July 12, 2018

Product Change Notice - New screen door latch, latch plate and slider

Fig.1

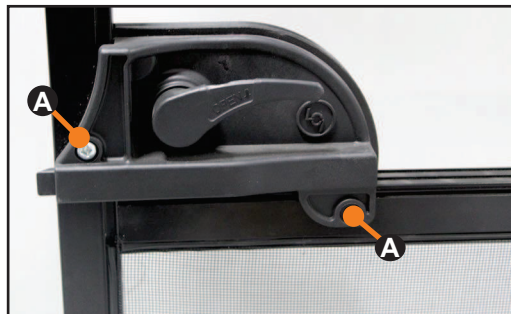
The new latch (Fig. 1) has a handle on both sides, which eliminates the need to open the screen door slider panel to exit the coach. The new handle snaps over the screen door frame in an L shape for a tight fit and added durability. Installation includes two screws (Fig. 1A). A new latch plate (Fig. 2) has also been added to match the new latch.

CURRENT: Screen door handle.

NEW: Screen door handle: Outside of screen door (top) and inside of screen door (bottom).

Fig.2

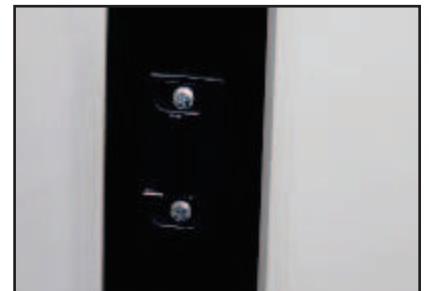
CURRENT: Latch plate.

NEW: Latch plate.

Fig.3

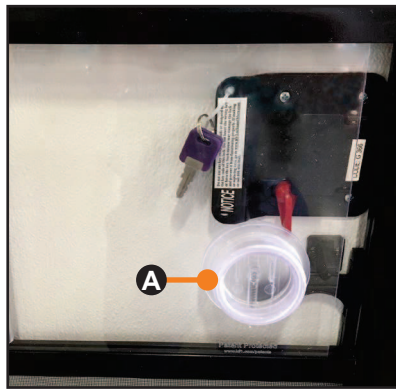
The plastic slider panel has also been updated (Fig. 3). The new slider fits with the latch and since it does not need to be used to activate the screen door handle, the plastic "bubble" (Fig. 3A) has been eliminated for improved aesthetics. The slider is available in clear or black.

CURRENT: Screen door slider

NEW: Screen door slider, black.

NEW: Screen door slider, clear.
